# CITY OF SAN ANTONIO

GUILBEAU PARK SUBDIVISION  
MASTER DEVELOPMENT PLAN

Re: Guilbeau Park

Please be advised that the Preliminary Overall Area Development Plan (POADP) review for Guilbeau Park (File #83-10-61-24) has been completed. The proposed scheme was jointly reviewed by Traffic Engineering and Planning staff. Analysis of the POADP concludes that the planned proposal is in general compliance with the requirements set forth in Chapter 36 of the City Code.

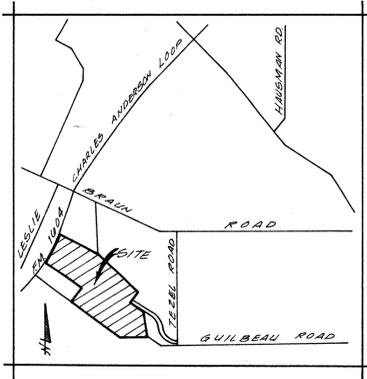
As per your engineer's inquiry, regarding a street extension (April Bend Street) which stubs into your property. Please note that the City of San Antonio will not obligate you to extend said street unless you choose to extend it to Guilbeau Road.

The street stub proposed at the north end of April Bend does not obligate the City of San Antonio to ensure extension of April Bend at a later date. (See attached)

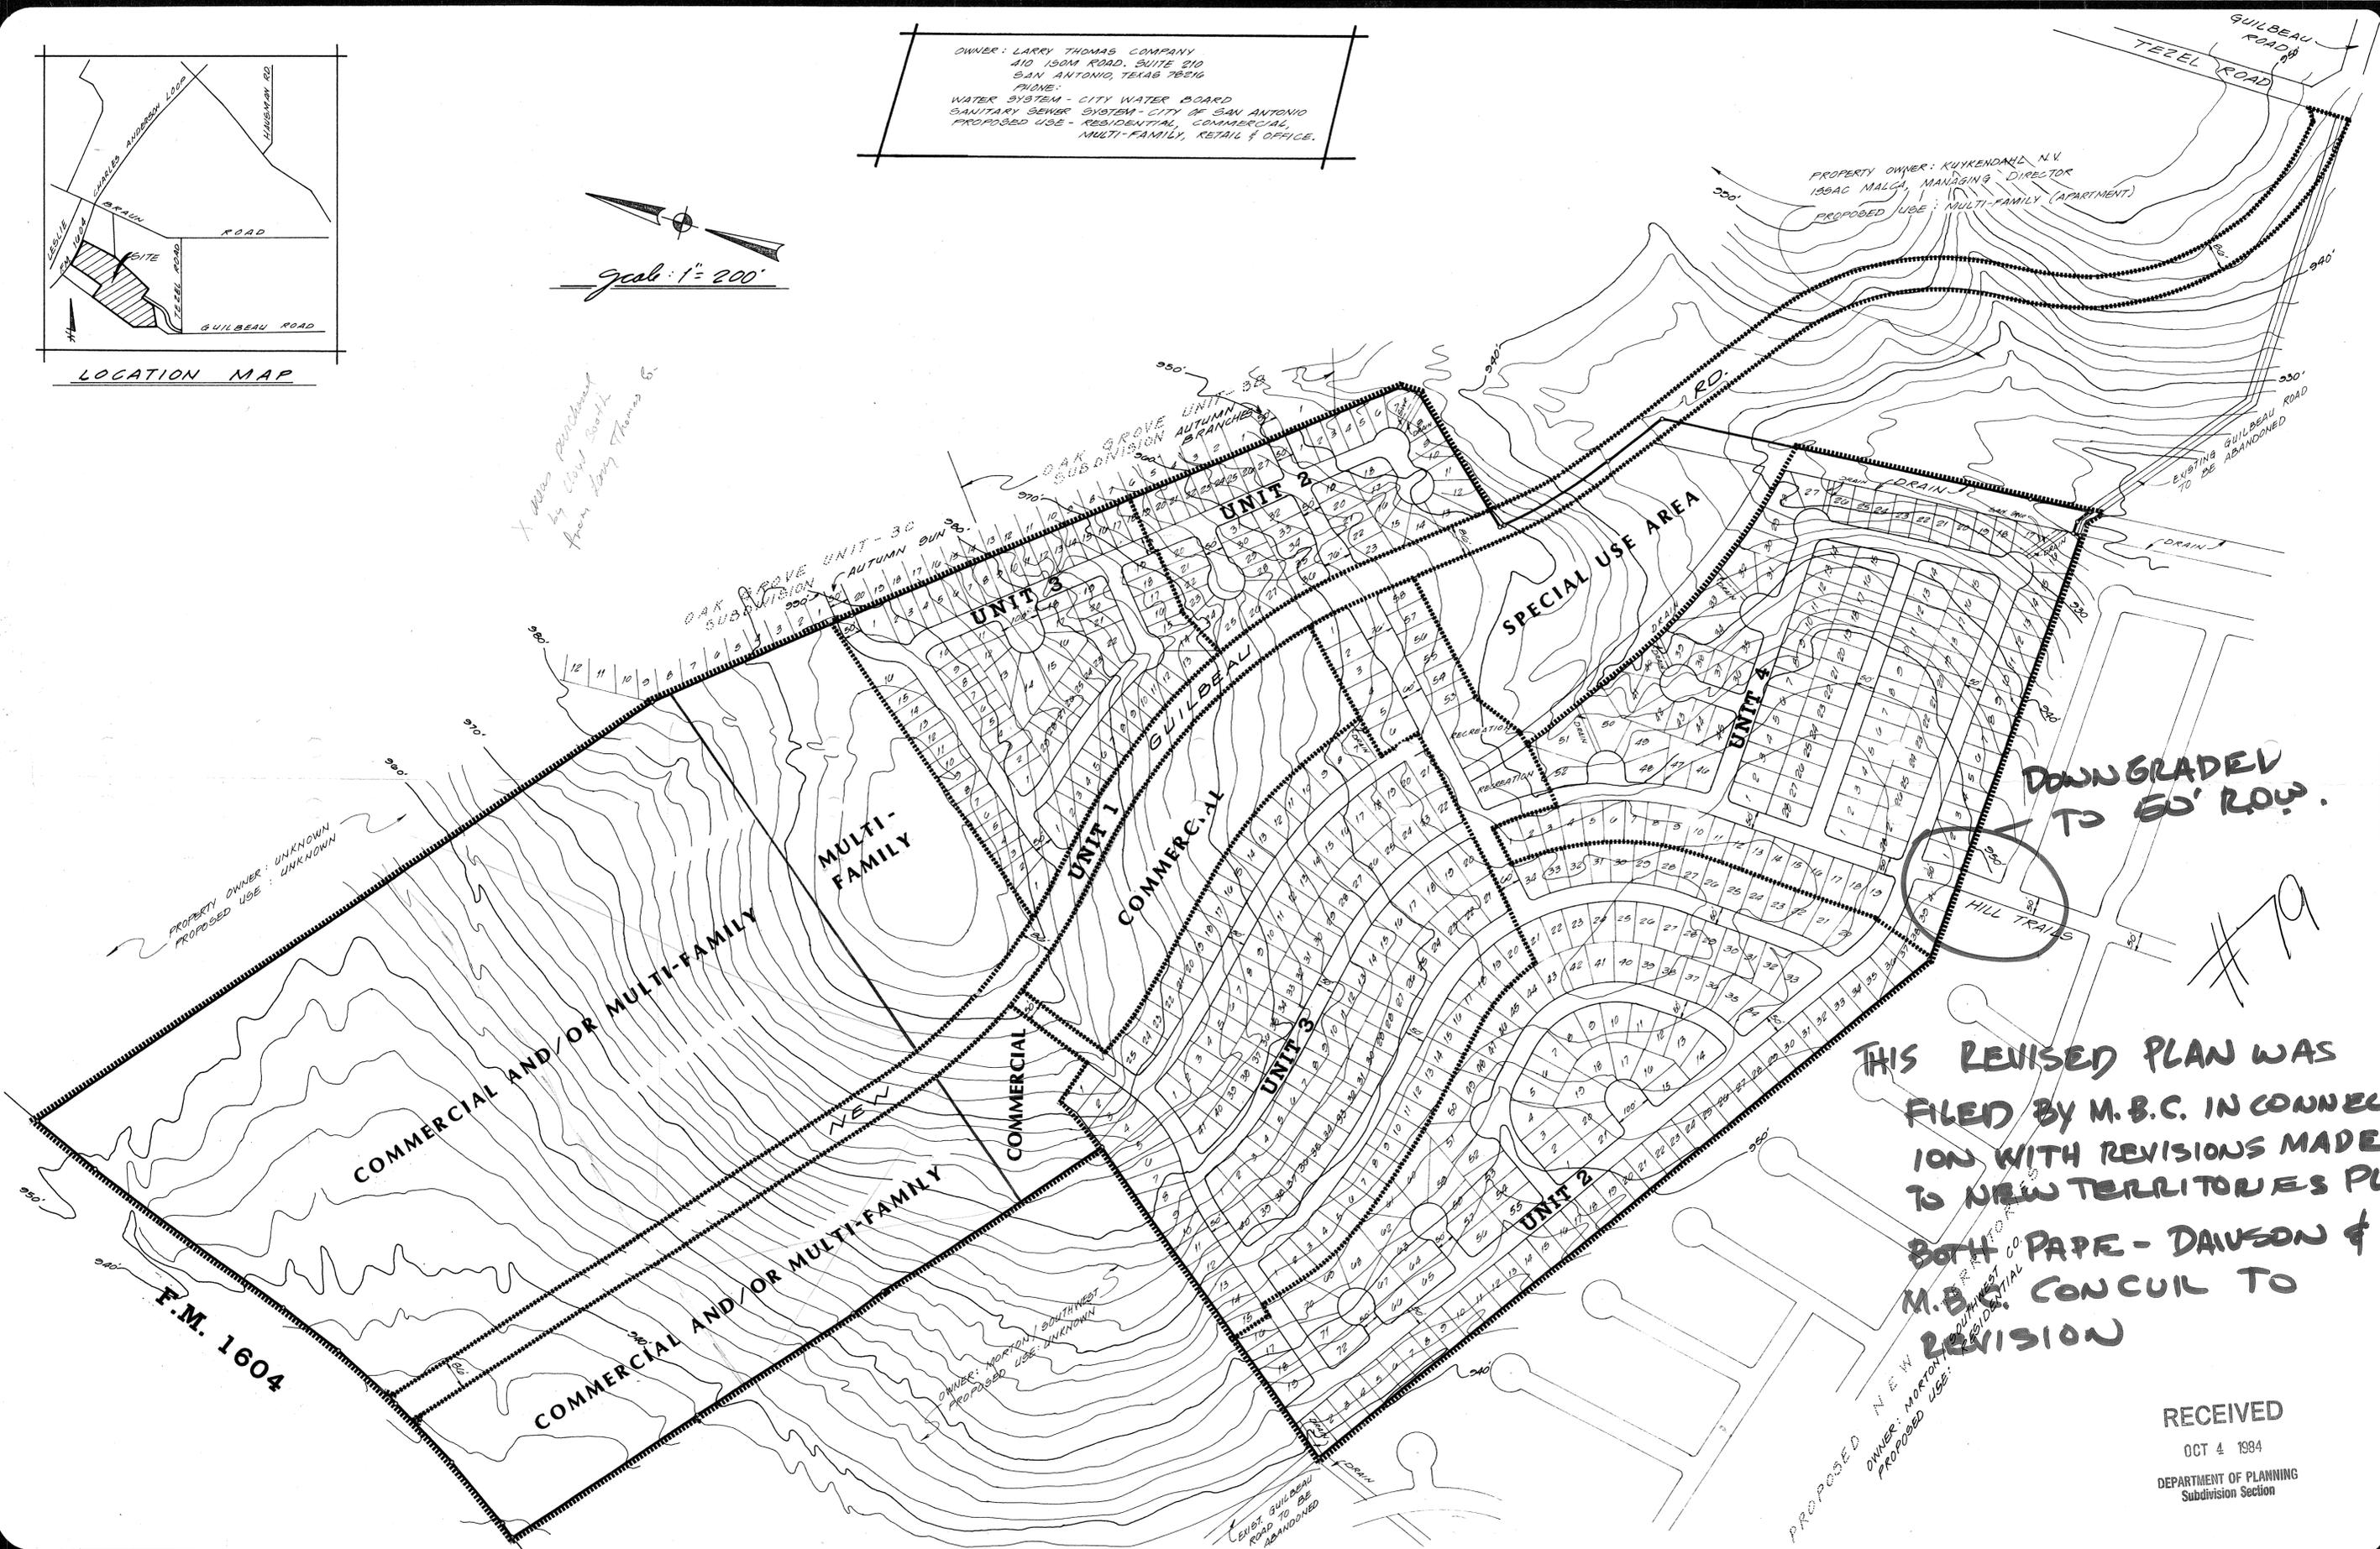
Staff concensus is that the planned Guilbeau Parkway (86' R.O.W.) alignment is in accordance with the current Major Thoroughfare Plan. Additionally, it is noted that the extension of Hill Trails in your subdivision is not consistent with the 60' R.O.W. being provided in that New Territories area. Because of this, it is recommended contact be made with the adjacent property owners in an effort to work out the inconsistency.
